**Date:** May 22, 2019  
**To:** Planning Board  
**From:** Lincoln Daley, Community Development Director  
**Subject:** Family Dental Care of Milford for the property located at Tax Map 19, Lot 13, 150 Elm Street and Tax Map 19, Lot 14, 154 Elm Street. Public hearing for a Major Site Plan application to construct a 5,400 square foot addition to the existing 2,400 square foot dental office and related parking, landscaping, lighting, and drainage improvements within in the Commercial District and Nashua-Elm Street Overlay District.

**BACKGROUND/PROPOSAL:**

PROJECT #337 SHEET 1 of 15

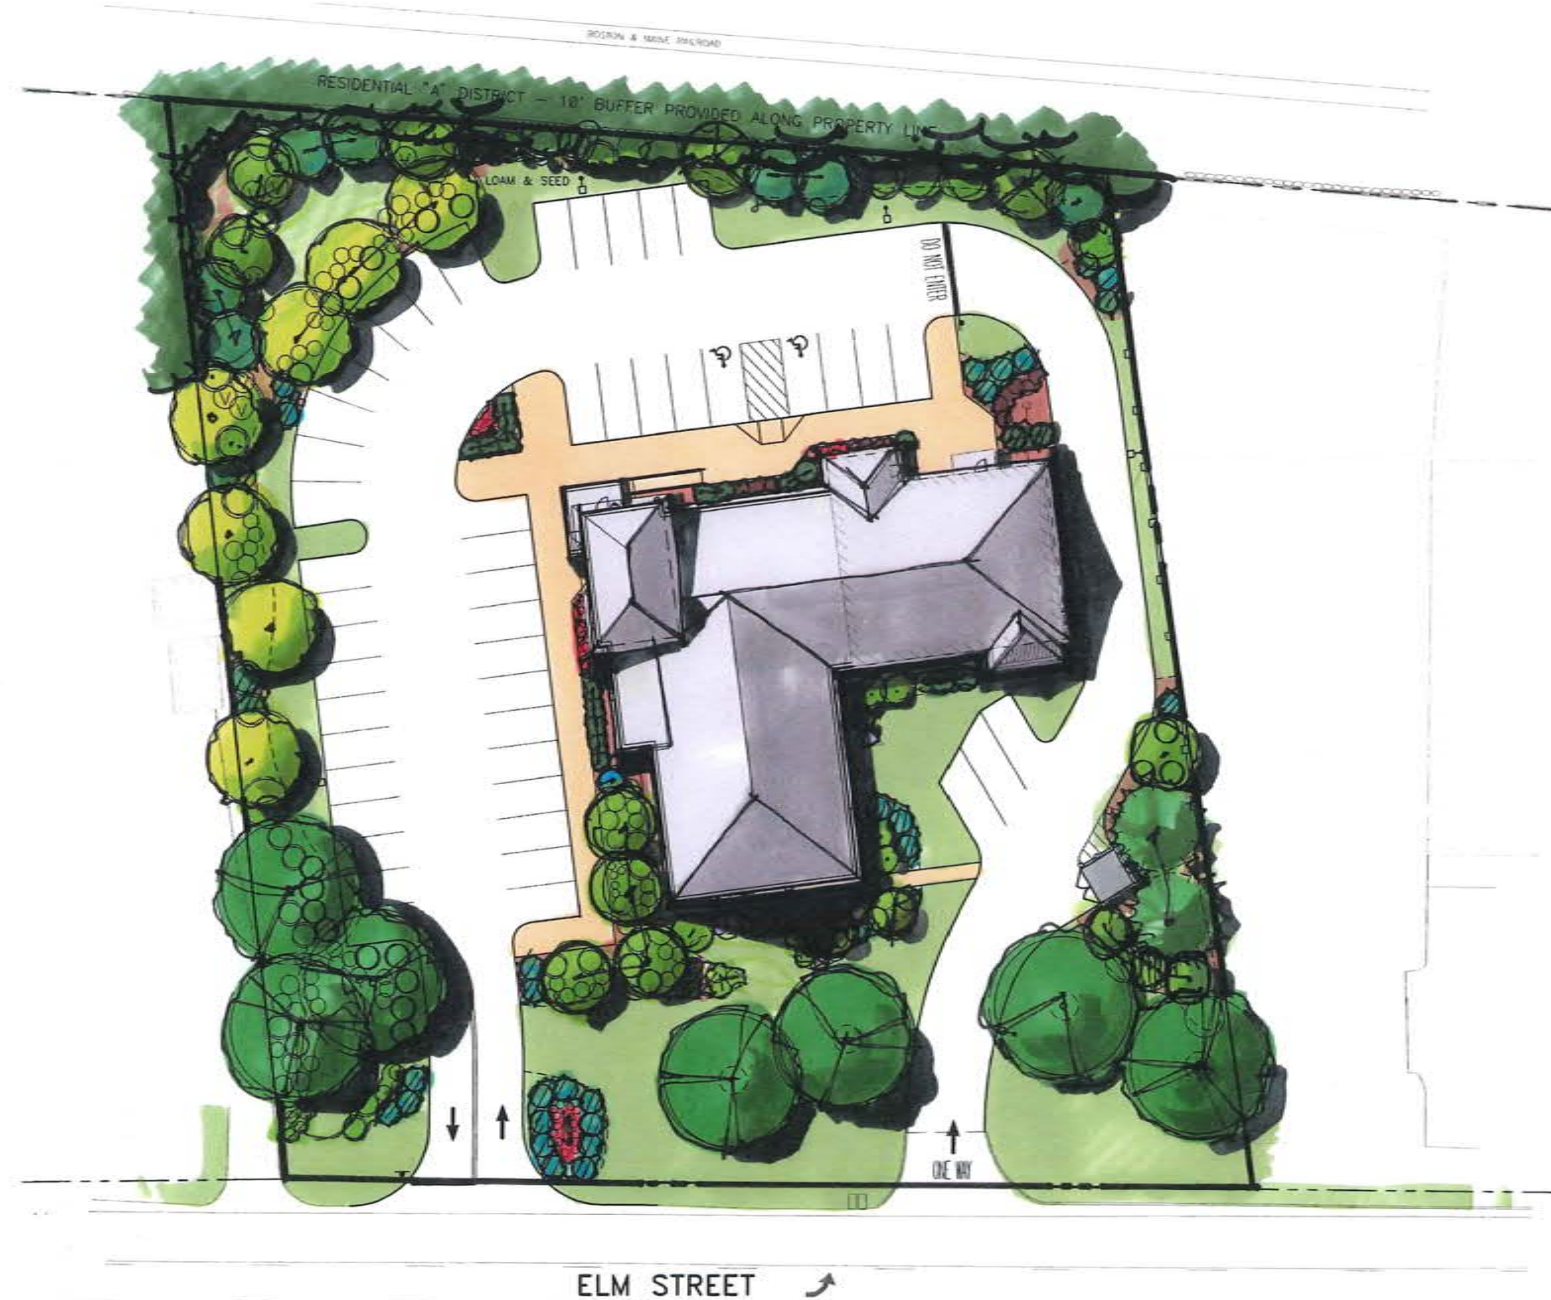
1. Sheet 1. Please revise the plan to include signature blocks for the Planning Board and Property Owner and resubmit.
2. Sheet 1. Waiver Requests. Recommend incorporating the Waiver Requests Block into a general Notes block.

SHEET TITLE:  
**EXISTING CONDITIONS PLAN**

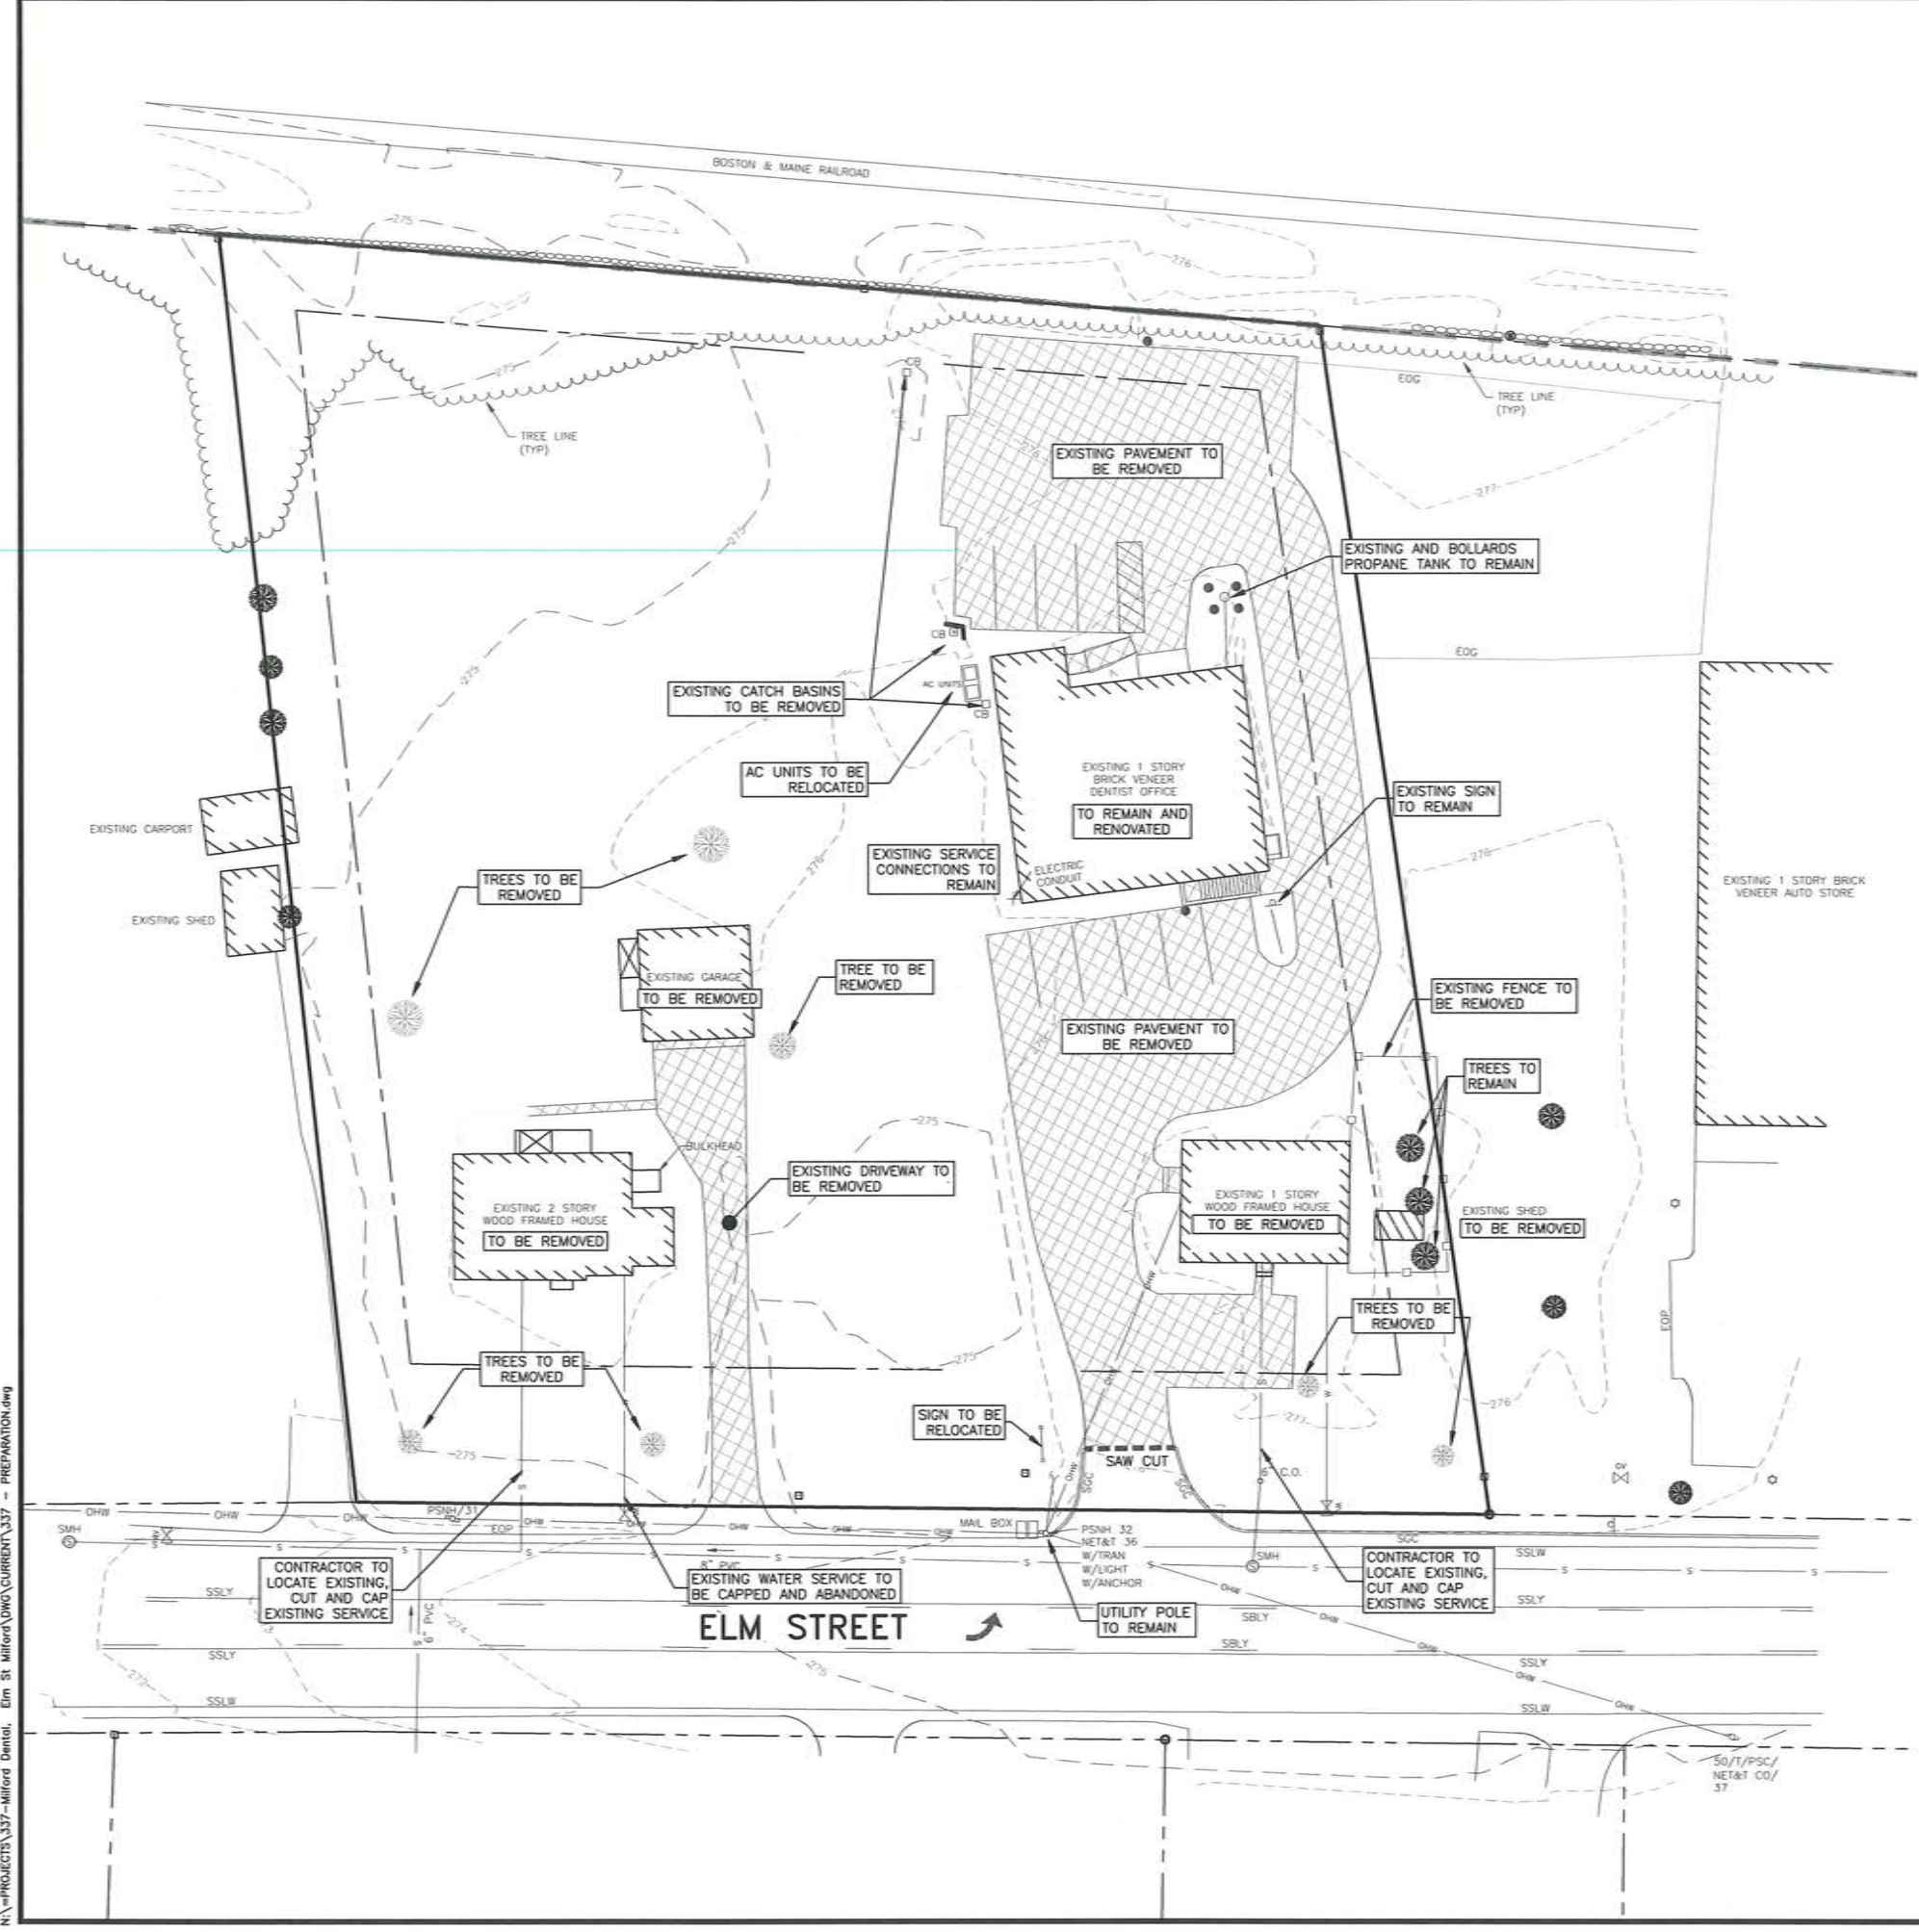
3. Further, please add the following notes:
  - a. A note indication that the project is subject to Police Impact Fees.
  - b. Sheet 2. Please revise the plan by addition a note stating the properties lie within the Groundwater Protection Level 1 District.

- c. Sheet 2. Please revise the plan by revising Note 4 to state that the properties are subject the design and performance standards of the Nashua Elm Street Overlay District.

SHEET TITLE:  
**PREPARATION PLAN**

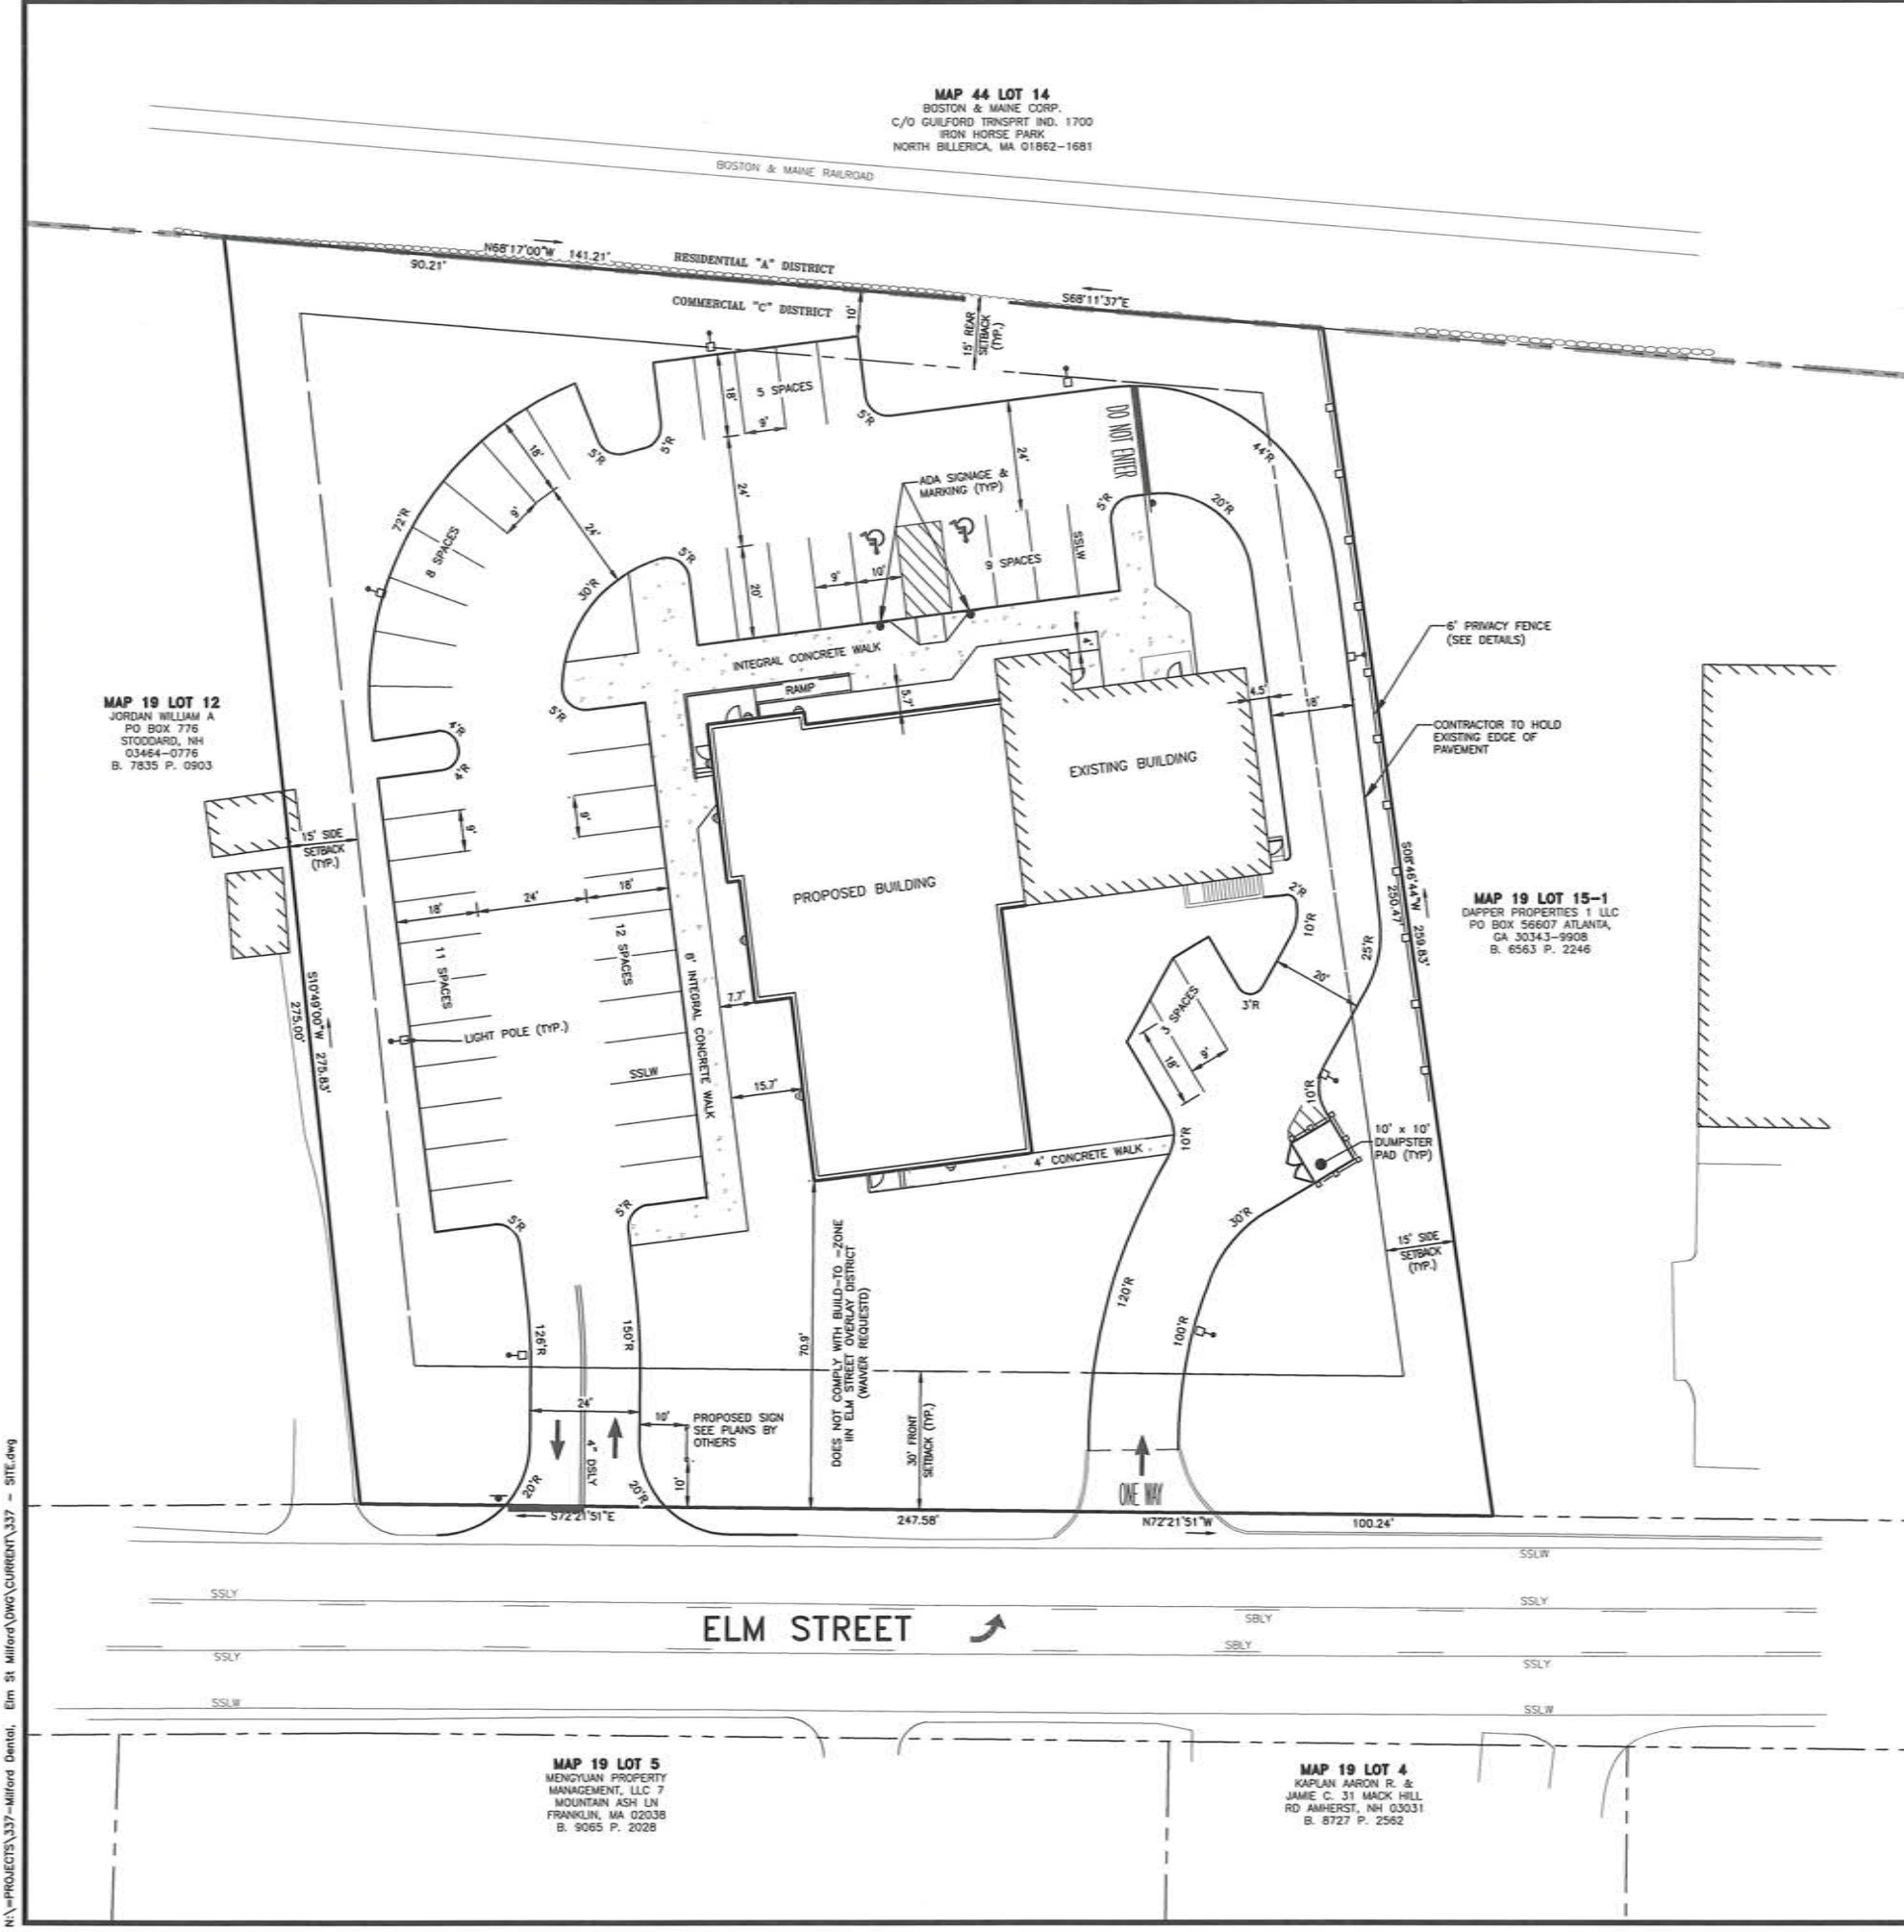
4. Sheet 3, Landscape Maintenance. Please clarify the method of irrigating the landscaping elements.
5. Sheet 3, Landscape Maintenance. Please add a note to the plan stating the following, “Any landscape element that dies, or is otherwise removed, shall be promptly replaced with the same, if not similar to, height or texture element as originally intended. In addition, landscaped areas shall be kept free of all debris, rubbish, weeds and overgrown turf grass.”
